**RE: INFORMATION REQUEST RESPONSE - FOR 176 BAILEYS MOUNTAIN ROAD, UPPER
COOMERA – OPEN SPACE & LANDSCAPE RESPONSE**

Landscape Concept Design

41-53 COURTNEY DRIVE UPPER COOMERA

July 2025 | 11694 | Issue C

- ▬ SITE BOUNDARY
- ▬ WATER SERVICES
- ▬ STORMWATER SERVICES
- ▬ SEWERAGE SERVICES
- - DRAINAGE SWALE LOCATION

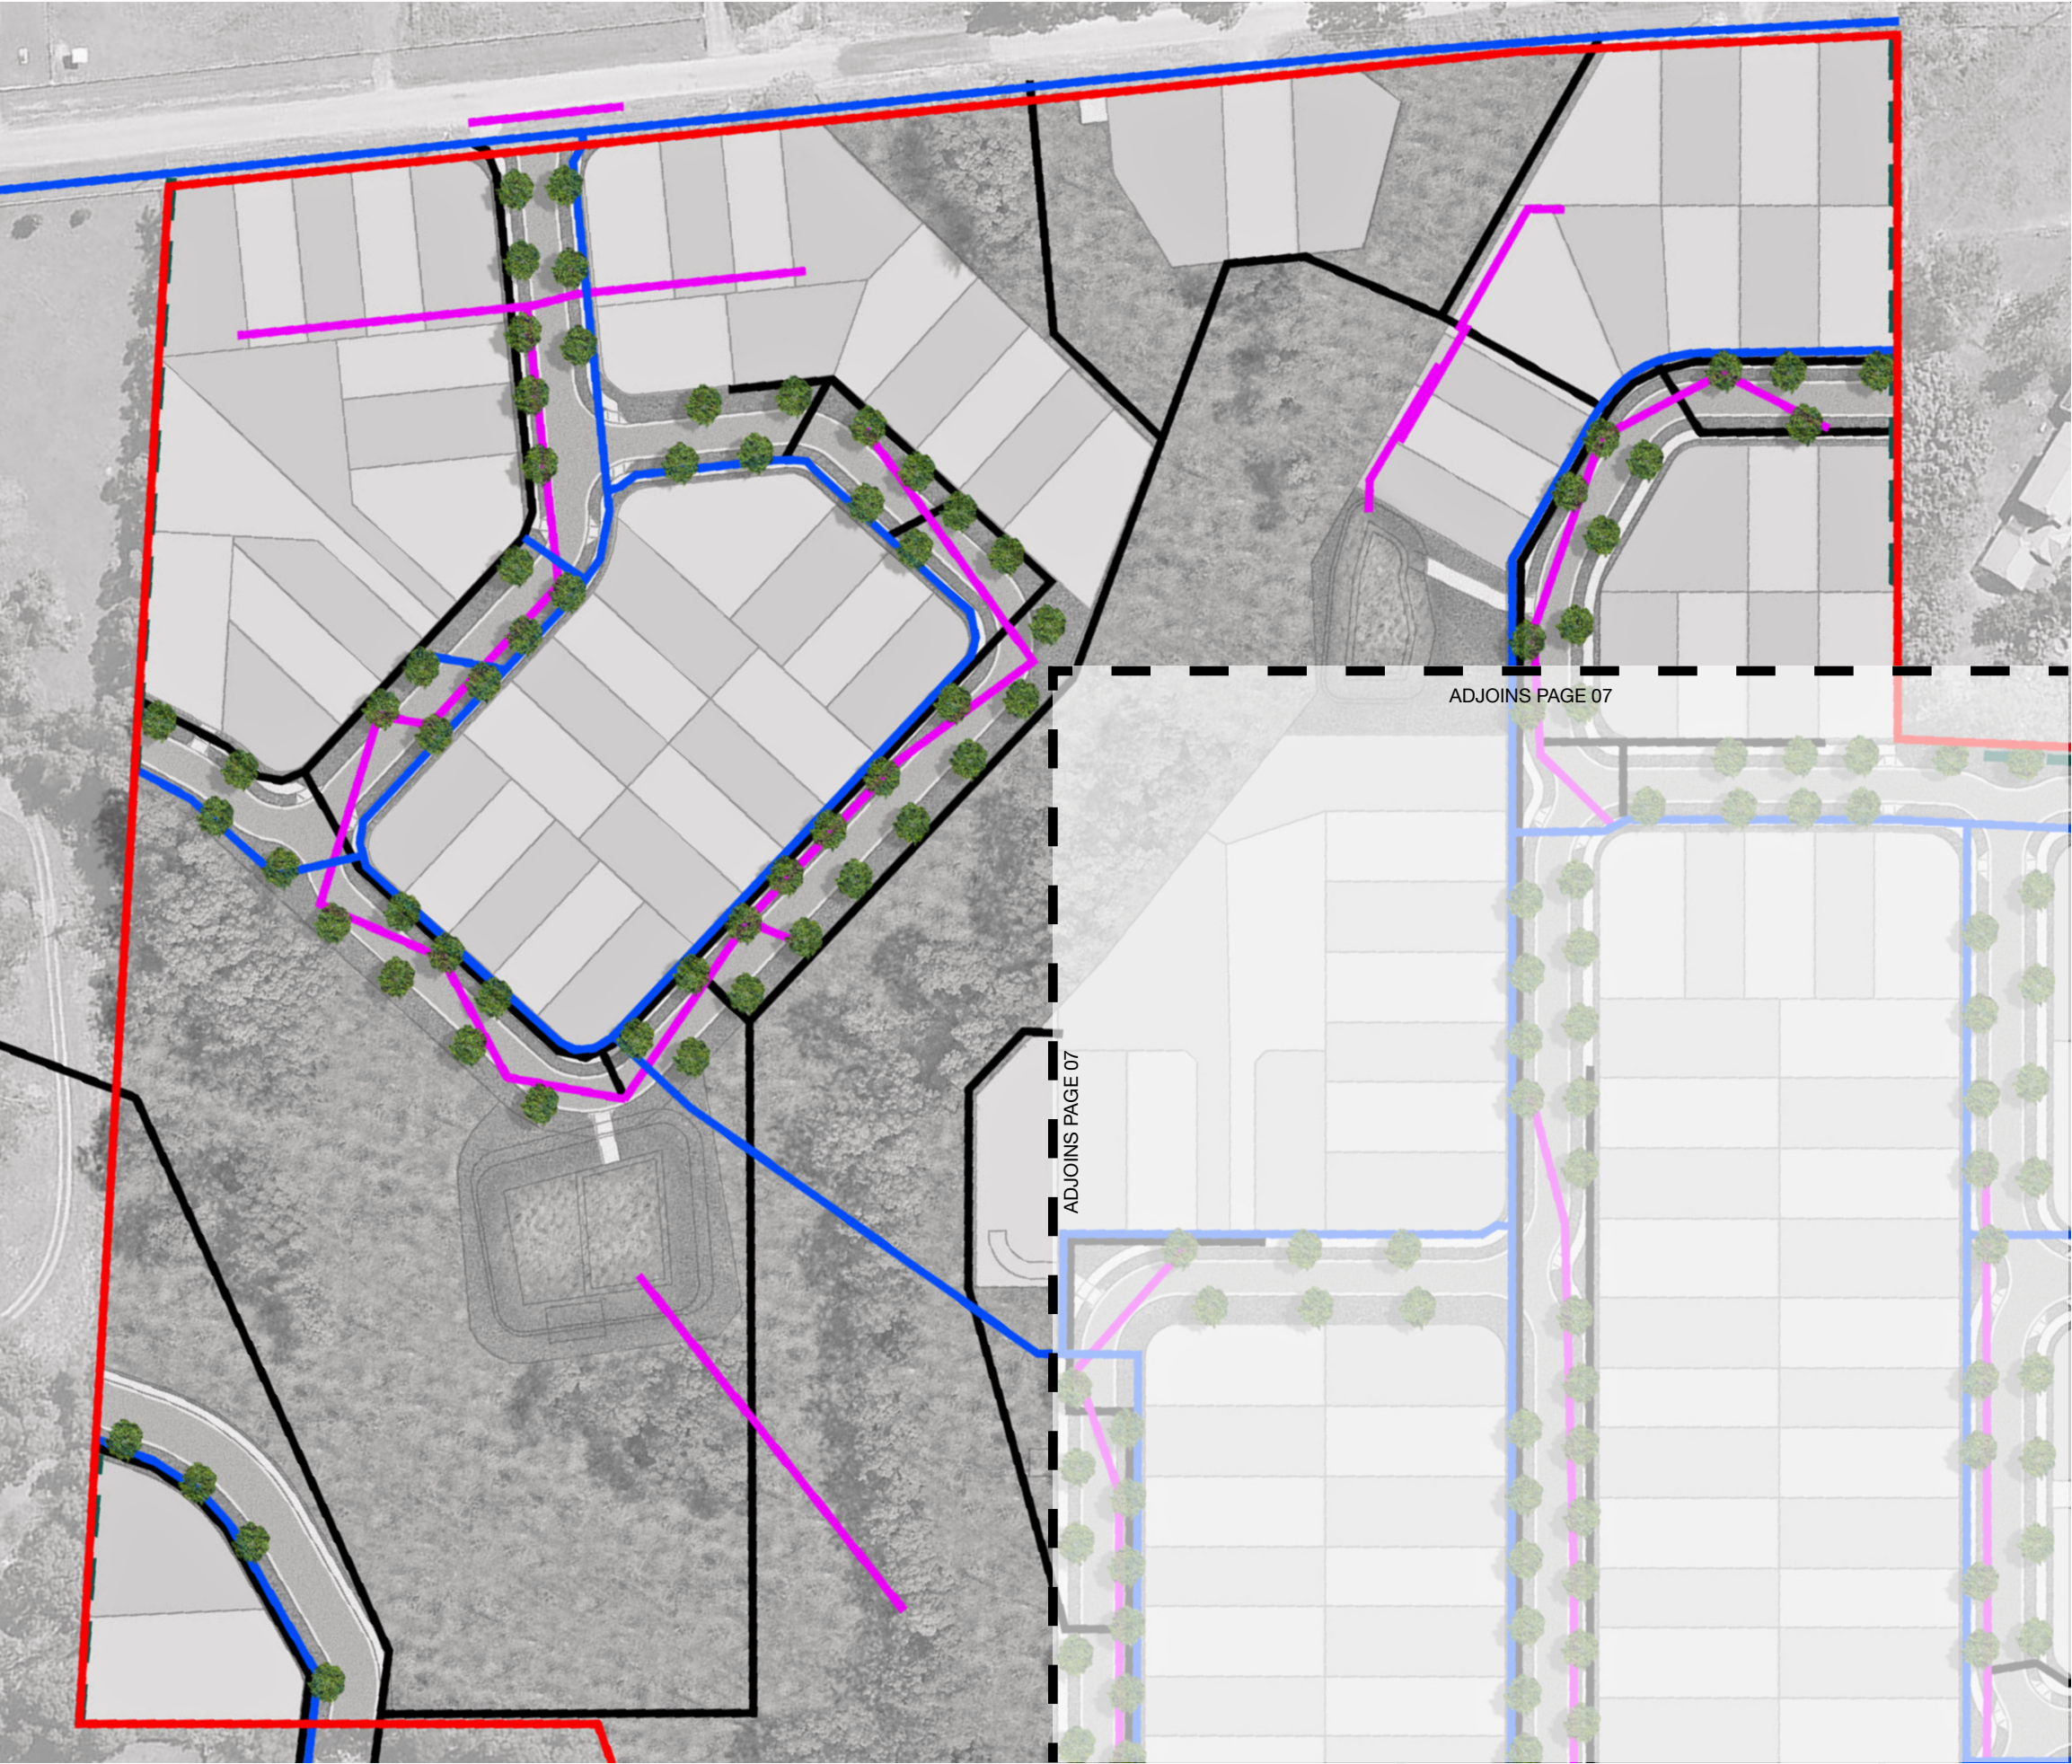
Officers note the submitted drawings include stormwater infrastructure located within the new road reserves directly behind the back of kerb which may impact future street tree planting. Additionally, the submitted drawings do not identify the vehicle cross-over (VXO) locations for the proposed lots, which will limit opportunity for new street tree planting. In order to provide street tree planting within the road reserves in accordance with Performance outcomes PO15 and PO18 of the Reconfiguring a lot code, the applicant is requested to submit amended drawings reflecting the following:

- a. All infrastructure lines (including pipes for water, sewer and stormwater) nominated within the road reserve are requested to be located outside the area from the back of kerb to ensure street tree planting is able to be incorporated.*
- b. An amended plan nominating the VXO location for each lot is requested to be submitted ensuring sufficient space is available for street tree planting.*

c. Street tree planting is requested to be nominated within the residential subdivision in compliance with SC6.12 City Plan policy □ Land development guidelines and SC6.13 City Plan policy □ Landscape work.

d. An amended Statement of Landscape Intent (SLI) is requested to be submitted reflecting the amended street tree planting locations in conjunction with services and VXO locations within the new road reserves.

Landscape plans updated to include reflect latest driveway, stormwater, water & sewer services and indicative tree set out adapted to suit where appropriate. Refer to pages 7–10 of landscape concept package.

- ▬ SITE BOUNDARY
- ▬ RETAINING WALLS
- ▬ HIGH QUALITY RETAINING WALL
Provide high quality retaining wall to improve site amenity where walls are exposed to road reserve. Split face texture or similar finish. - Final Spec TBC
- ➡ DRIVEWAY LOCATIONS
(Final locations TBD)

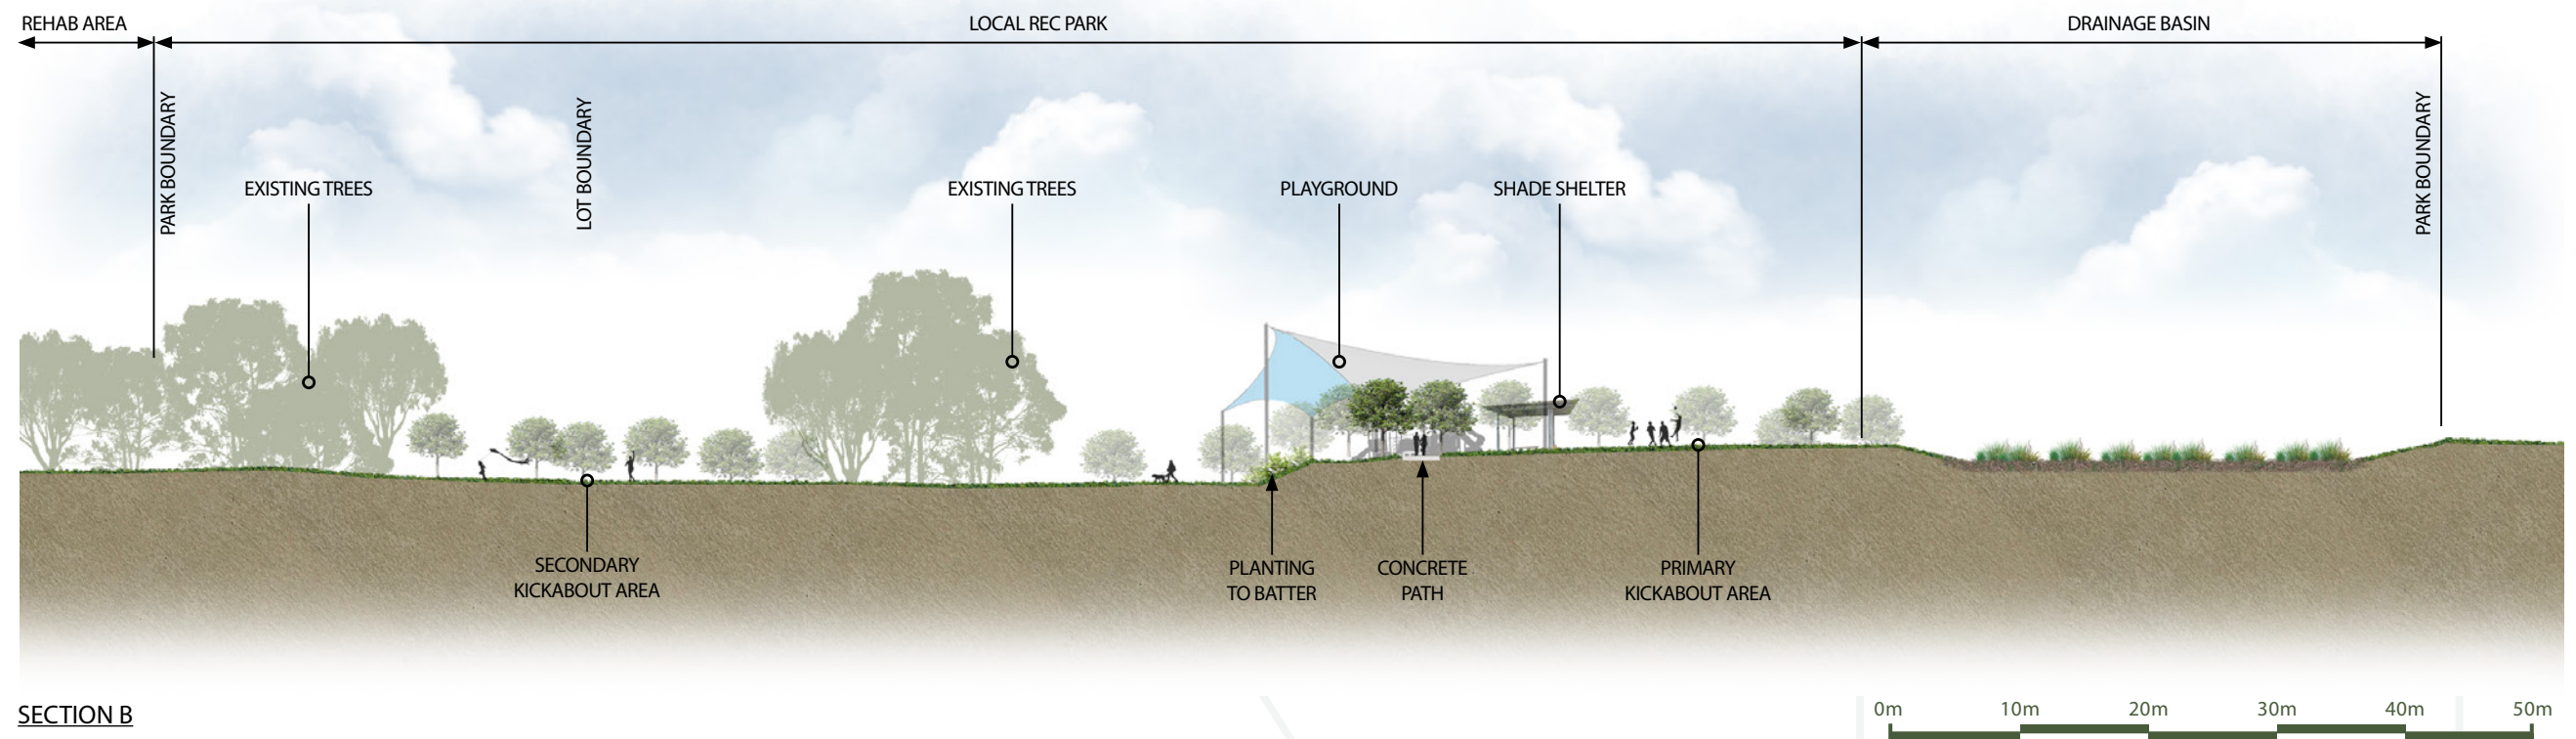
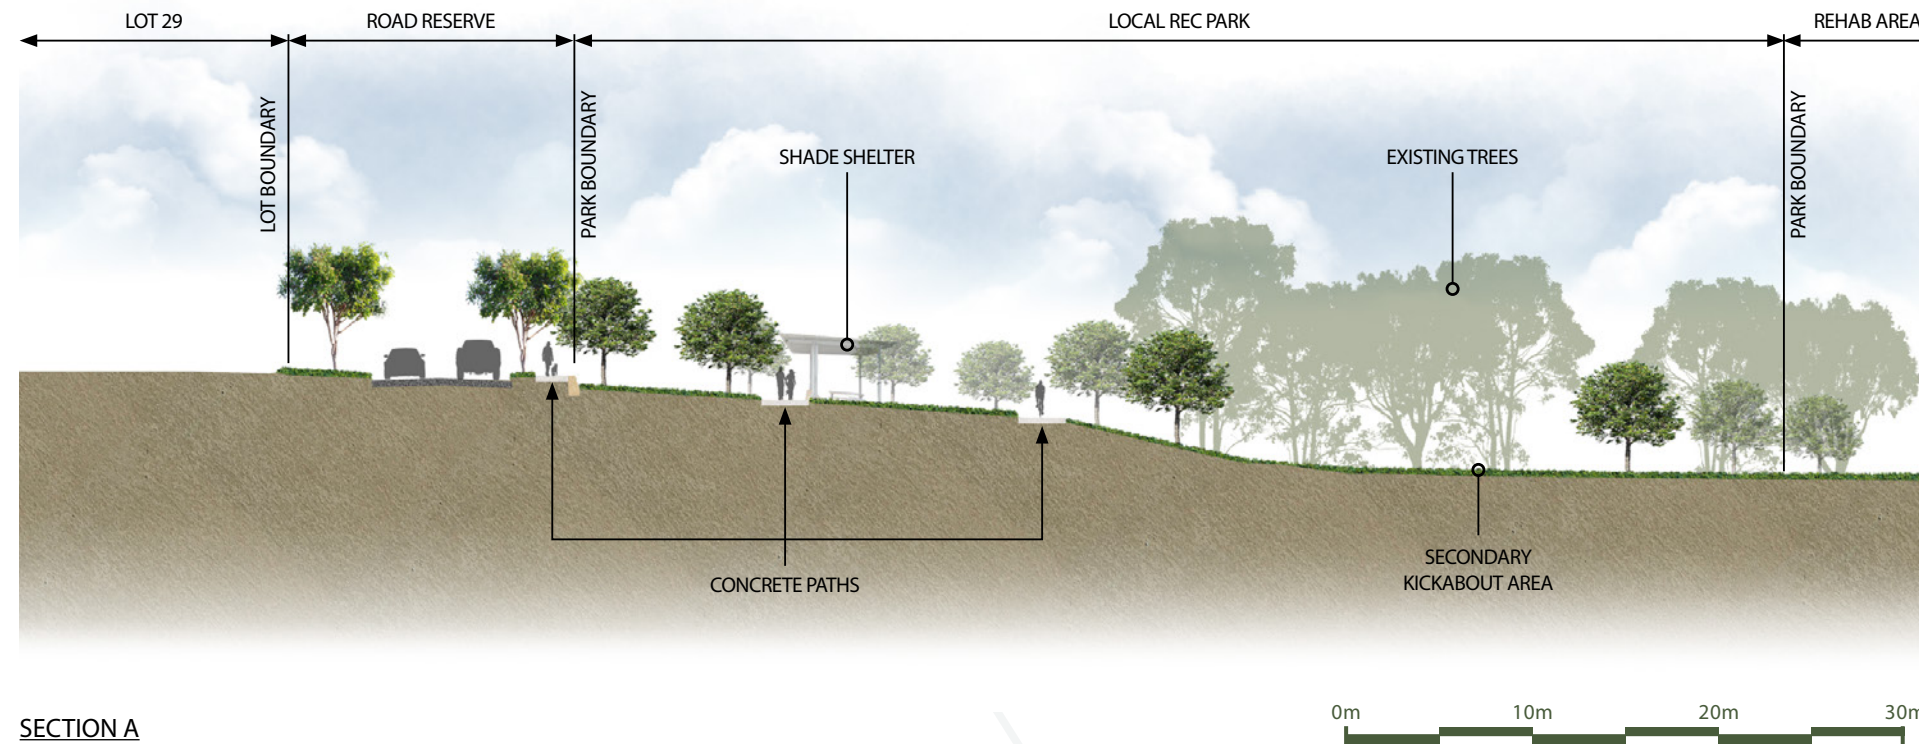
The submitted preliminary earthworks plans nominate retaining works to be constructed within the individual lots which will front current and future road reserves in addition to conservation areas. Officers have concerns with the amenity appearance in accordance with Performance outcome PO9 of the General development provisions code and the applicant is requested to submit amended drawings reflecting the following:

a. The proposed 1.5m □ 3.0m high retaining wall nominated along the front boundary of Lot 100 is considered to negatively impact the frontage interface of Courtney Drive. Officers request for the retaining works (and associated footings) to be setback a minimum 600mm to provide space for screening shrub planting to be incorporated between the retaining wall and the boundary fronting Courtney Drive.

b. The proposed retaining wall nominated along the front boundary of proposed Lots 16 & 17 adjacent future Road 01 are requested to be setback a minimum 600mm to provide space for screening shrub planting between the wall and the future road reserve.

- c. The proposed retaining wall nominated along the front boundary of proposed Lots 62 and 63 adjacent Road 02 are requested to be setback a minimum 600mm to provide space for screening shrub planting between the wall and the future road reserve.*

- d. For any other proposed retaining walls (and associated footings) along a front boundary (or future front boundary) not listed above are requested to setback a minimum 600mm from the front boundary to allow for garden area between the retaining wall and front boundary.*

- e. Any proposed retaining wall within the subject site is requested to incorporate a high-quality design by incorporating split face textured material which are provided in a charcoal colour. It is also requested that the type of wall is specified, noting that a wall type with a narrower footprint (e.g. concrete sleeper) will have less impact on the usable areas on the lots.*

- f. An updated Statement of Landscape Intent (SLI) is requested to be submitted identifying the retaining wall locations within the private land and garden areas incorporating screening shrubs where these retaining works are requested to be setbacks from a boundary.*

Landscape plans updated to include a high-quality retaining wall where exposed to road reserve – final spec TBC. Refer to Page 9-10 in Landscape Concept Package.
